BANDERA & GUILBEAU RD. MIX-USE DEVELOPMENT

P.O.A. D.P. PLAN

INFORMATION SHEET FOR
PRELIMINARY OVERALL AREA DEVELOPMENT PLAN
(P.O.A.D.P.)

☐ Preliminary Plan
Re: Bandera & Guilbeau ☒ P.O.A.D.P.
File #: 85-11-64-42

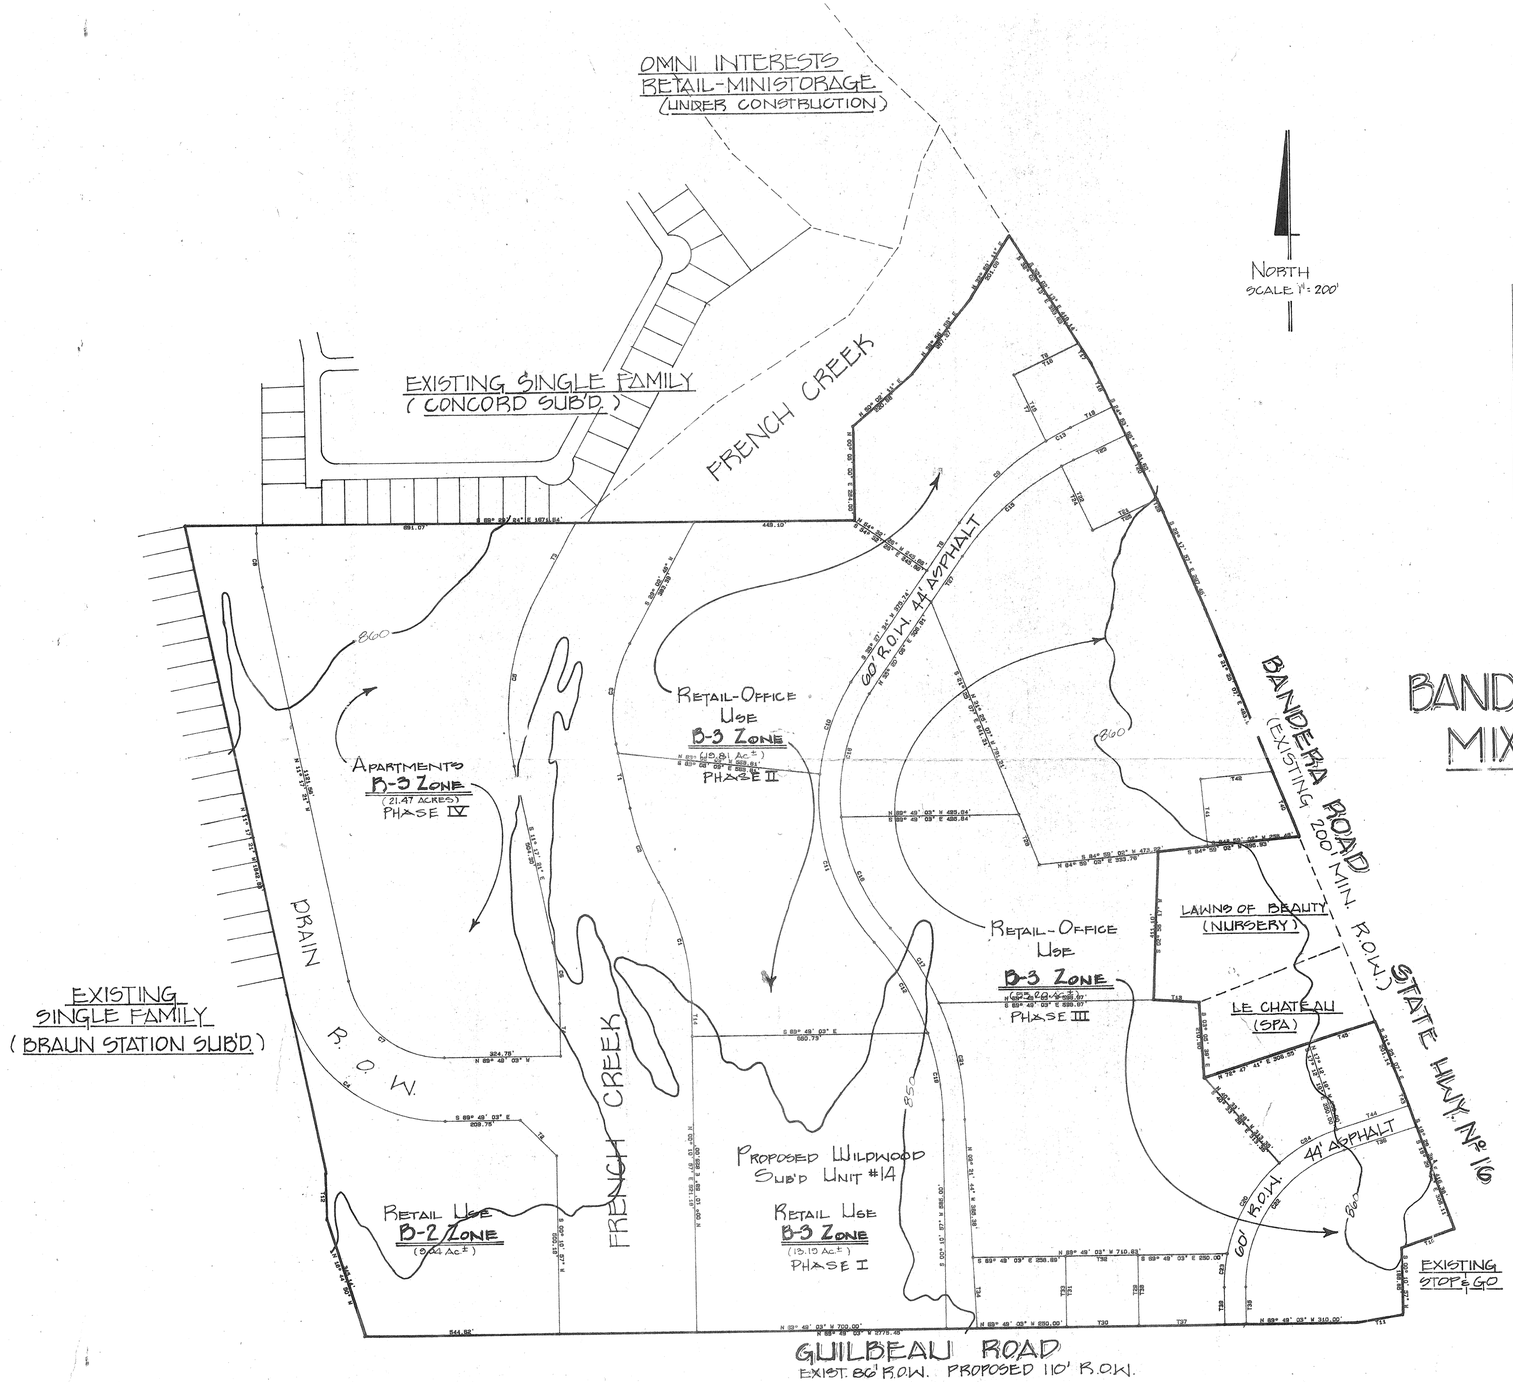
(X) lacks compliance with the Subdivision Regulations regarding:

- ( ) Street layout
- ( ) Relation to adjoining street system
- ( ) Stub streets
- ( ) Street jogs or intersections
- ( ) Dead-end streets
- ( ) Cul-de-sac streets in excess of 500'
- ( ) Low density lots fronting onto major thoroughfares
- ( ) 24' alley(s)
- (X) 36-19(3)(b)(1) Public Street Frontage

The POADP Committee has reviewed your proposed plan for Bandera-Guilbeau development. The concensus of the Committee is that the proposed Phase IV apartments will require access from other than the adjacent single family development (Concord Subdivision). The Committee's recommendation is that the plan be revised to indicate a local type "B" street to serve the proposed apartments. If Phase IV is developed as single family, then access from other than Concord Subdivision would not be required.

Your plan will be held in obeyance pending a revised plan. If you have any questions regarding staff comments, please contact our Subdivision Section at 299-7900.
